Service Bulletin SB0073

Date: December 2004
From: Capstone Technical Support
Subject: Wiring Interlock between Multiple C30 MicroTurbines with
Common Exhaust Duct

All Capstone Turbine Corporation[®] Model C30 systems operating with a common exhaust duct including systems with back flow dampers.

Figure 1. MicroTurbine - MicroTurbine Interconnections

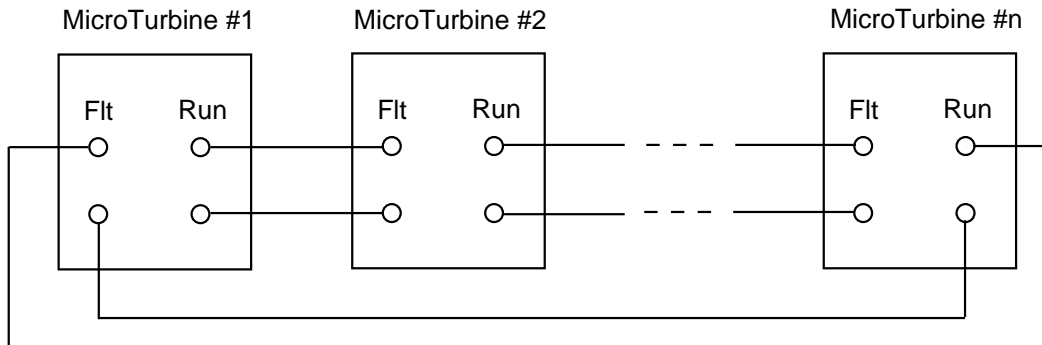
The back flow damper on two or more MicroTurbine systems sharing a common exhaust duct may warp after exposure to heat. This damper failure may affect the seal that prevents exhaust back flow and cause hot exhaust from an operating MicroTurbine unit to flow backwards through a non-operating MicroTurbine unit.

Reverse flow of hot exhaust may cause overheating of the generator and engine inlet components, resulting in damage to those components. In addition, damage to the non-operating MicroTurbine can result during a start of another unit due to backpressure on the engine's rotating components.

All MicroTurbines on a common duct must run simultaneously at the same power level. In addition, Capstone requires a wiring interlock mechanism to be installed between MicroTurbine systems.

Connect MicroTurbine #1 Output Relay 1 to MicroTurbine #2 Fault Input 1.
Connect MicroTurbine #2 Fault Input 1 to MicroTurbine #1 Output Relay 1.

Output Relay 1 – Connector TB5 - Pins 1 and 2

Fault Input 1 – Connector TB4 – Pins 5 and 6

Connect the last MicroTurbine # $\langle n \rangle$ Output Relay 1 to MicroTurbine # 1 Fault Input 1.
Connect MicroTurbine # $\langle n \rangle$ Fault Input 1 to MicroTurbine # $\langle n-1 \rangle$ Output Relay 1.

Output Relay 1 – Connector TB5 - Pins 1 and 2

Fault Input 1 – Connector TB4 – Pins 5 and 6

3. Set the following software parameters on each MicroTurbine using the display panel:
 - a) On the UCB Relays menu for Output Relay 1, program the state to Run and function to Active Open.
 - b) On the System Settings menu, program the Fault Input 1 to Enable, SSL to 3, and Time to 12 seconds.
